SUNDRY NOTICES AND REPORTS ON WELLS
Do not use this form for proposals to drill or to re-enter an abandoned well. Use Form 3160-3 (APD) for such proposals.

8. Well Name and No.
Poker Lake Unit 423H

BOPCO,L.P. is requesting approval to amend point 4 Pressure Control Equipment in the original APD as attached.

POINT 4: PRESSURE CONTROL EQUIPMENT (SEE ATTACHED DIAGRAMS A, B, or C)

**13-5/8" or 11" X 3-M BOPE (2 Rams and Rotating Head)
 & Closed Loop System Equipment Schematic
 Diagram A**

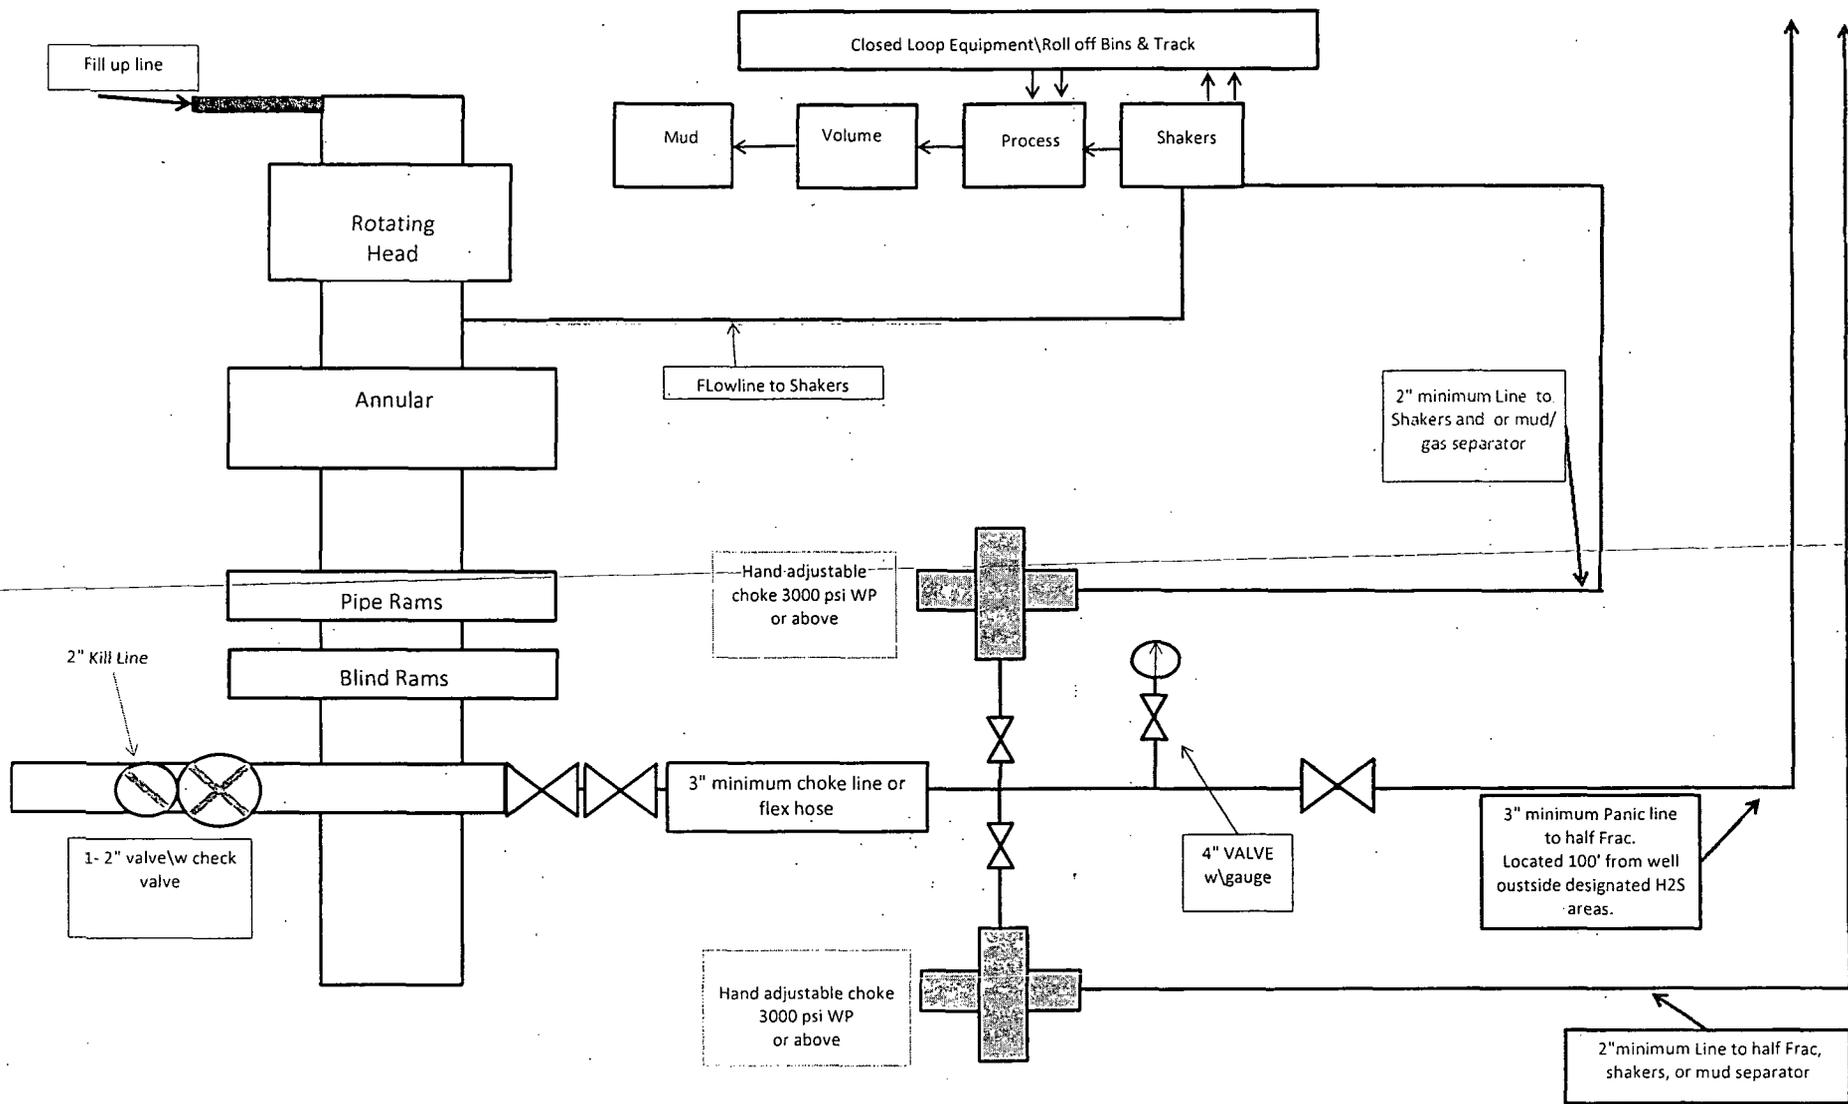
After running the 13-3/8" surface casing, a 13-5/8" BOP/BOPE system with a minimum rating of 3M will be installed, used, maintained and tested as per Onshore Order 2. In addition to the high pressure test, a low pressure (250-300 psig) test will be performed.

After running the 9-5/8" intermediate casing, a 13-5/8" or 11" BOP/BOPE system with a minimum rating of 3M will be installed on the 9-5/8" intermediate casing spool (8-3/4" open hole), used, maintained and tested as per Onshore Order 2. In addition to the high pressure test, a low pressure (250-300 psig) test will be performed.

After running the 7" intermediate casing, a 13-5/8" or 11" BOP/BOPE system with a minimum rating of 3M will be installed on the 9-5/8" intermediate casing spool (8-3/4" open hole), used, maintained and tested as per Onshore Order 2. In addition to the high pressure test, a low pressure (250-300 psig) test will be performed.
